COCKLE BAY WHARF REDEVELOPMENT (CONCEPT PROPOSAL) SSD 7684

Figure 34 Concept Envelope and building mass currently envisaged (Southern Shore of Cockle Bay)

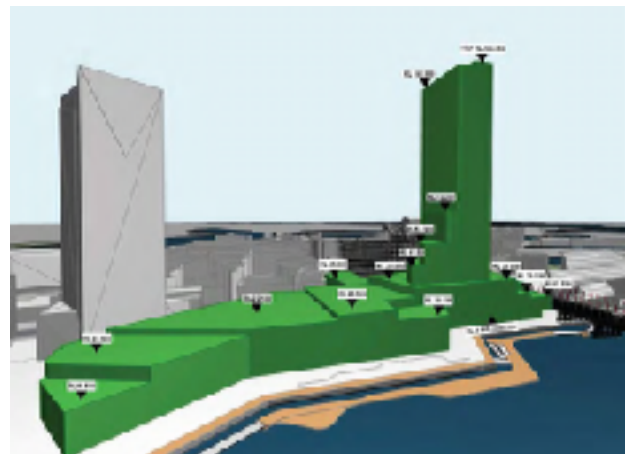
The cumulative impact of existing and proposed developments on Darling Harbour has not been adequately addressed

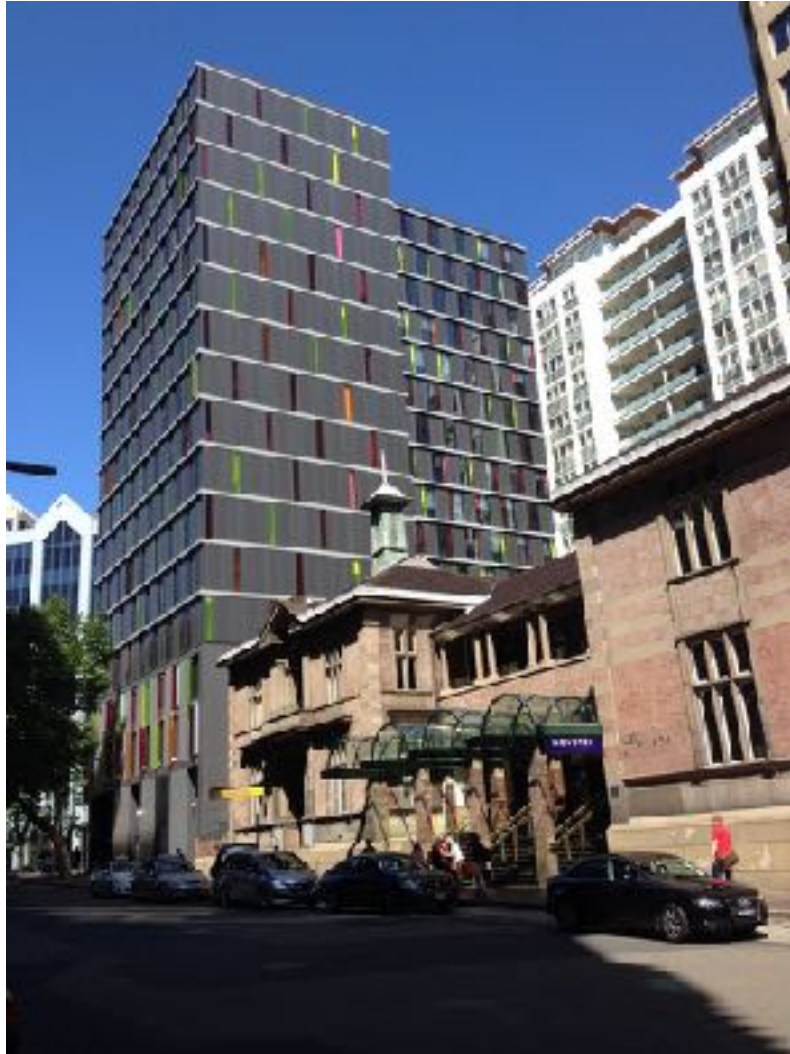
There has been cumulative development very close to the waters edge in Darling Harbour

Whilst new developments may not always impinge on the historic fabric of buildings, their scale and use of materials can diminish the older building, making it look small, grubby and out of place.
